Fire Officer Perspective: A Light Gauge Steel Case Study

John Cummins, SEFPO
Cork City Fire & Building Control Dept

Example Issue – LGS Separating Wall

- FSC application for a three storey LGS apartment building attached to a terrace of LGS houses in Cork City

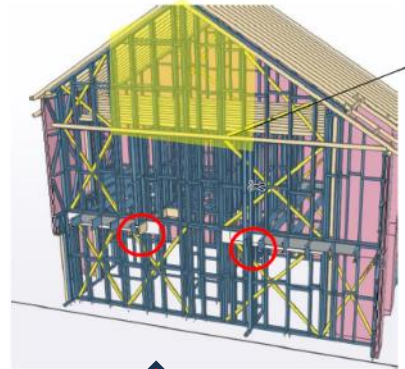
This  is tested

This  is built onto a 3 storey LGS apartment building

1. So how are the separating wall panels connected together vertically?
2. Are they relying on floors with lower fire resistance to hold them up?
3. What happens if the floor falls away and exposes LGS panels?

SD-057a - Joists to Party Wall

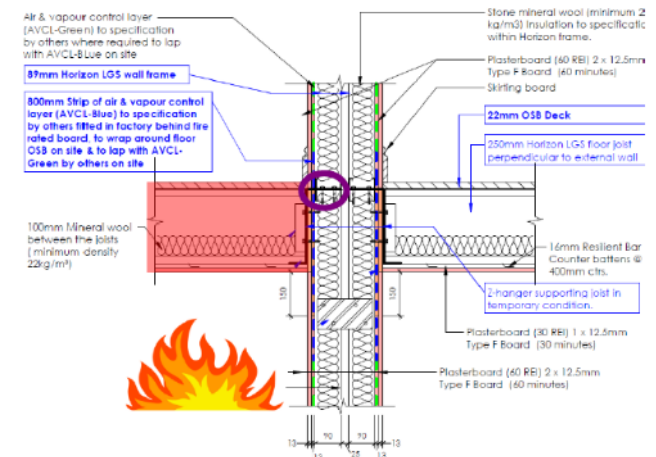
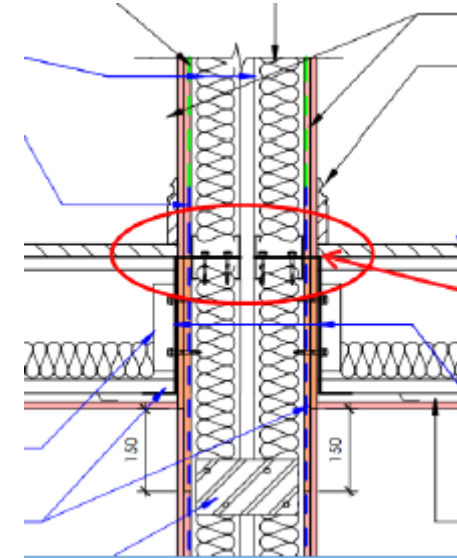
1. *How are the separating wall panels connected together vertically?*

2. *Are they relying on floors with lower fire resistance to hold them up?*

So do the floors have a lower level of fire resistance (elements of structure supporting?)

Screwed together at or around floor level

Yes, laterally supported by floors

Yes, but they would be supported by a floor on the other side of the wall in the event of a fire

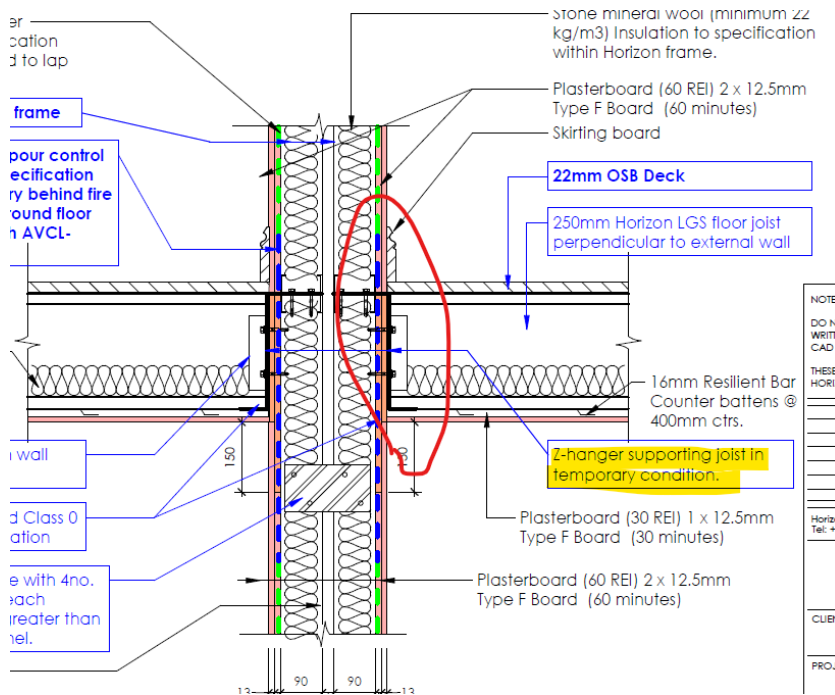
3. What happens if the floor falls away and exposes LGS panels to a fire?

Not sure about this... need more reassurance!

A steel 'Z hanger' will stay in place and protect the steel

Post test exposed side wall panel (source: Evolusion Innovation)

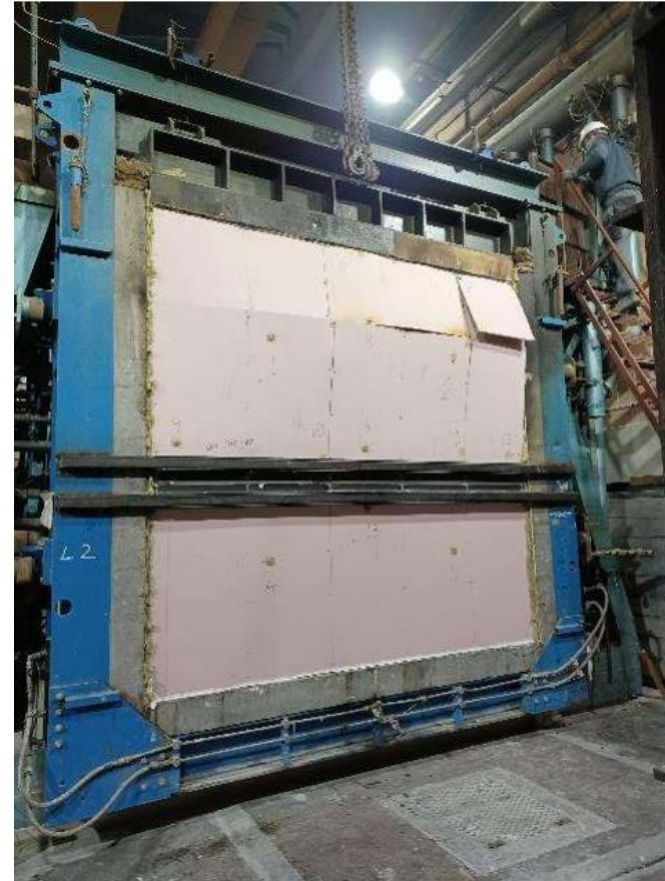
- Failure of '30 min' floor after 87 mins
- Passed load bearing capacity, integrity and insulation tests
- Protective longitudinal bracket connecting floor to wall stayed in place
- Plasterboard not mechanically damaged by floor falling away (59 mins)
- A pass?
